Dash / Part Number	Qty Req'd	Part Title	Next Assembly
<b>SubSonex</b> Electric Flap Installation			
Drawing Scale	Drawing Number	Revision	
None	JSX-C06	D

**Detail E**  
Warning Lights Wire Diagram

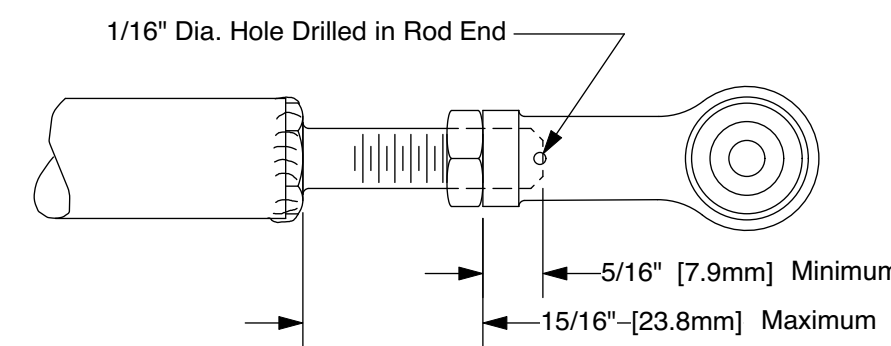
Revision Letter	Change Description	
A	Removed upgrade details when the electric flaps became standard equipment. Added Warning Lights Wire Diagram.	2.6.19
B	Added wiring schematics for Flap Actuator Motor and Potentiometer.	4.8.20
C	Detail B: Jam nut was AN365-428. Call-out for Detail D was Detail E. Detail C: Castle nut was AN310-3.	8.4.20
D	<b>Flap Actuator Change for Aircraft Serial Numbers JSX0052 and Later.</b> <b>Detail A:</b> - Replaced JSX-C03-64L with JSX-C03-70L Left Hand Flap Actuator Mount. - Replaced JSX-C03-64R with JSX-C03-70R Right Hand Flap Actuator Mount. <b>Detail B:</b> - Replaced JSX-C03-67 with JSX-C03-71 Flap Actuator. - Replaced JSX-C03-61 with JSX-C03-68 Electric Flap Push Rod. - Replaced JSX-C03-63 with JSX-C03-69 Electric Flap Actuator Switch Mount and Mounting Hardware. <b>Detail C:</b> - Updated Visual Depiction to show new JSX-C03-71 Flap Actuator installation. - Replaced AN4-13 with AN4-16 Bolt. <b>Detail F:</b> - Updated Potentiometer Wire Colors for JSX-C03-71 Flap Actuator.	05.08.23
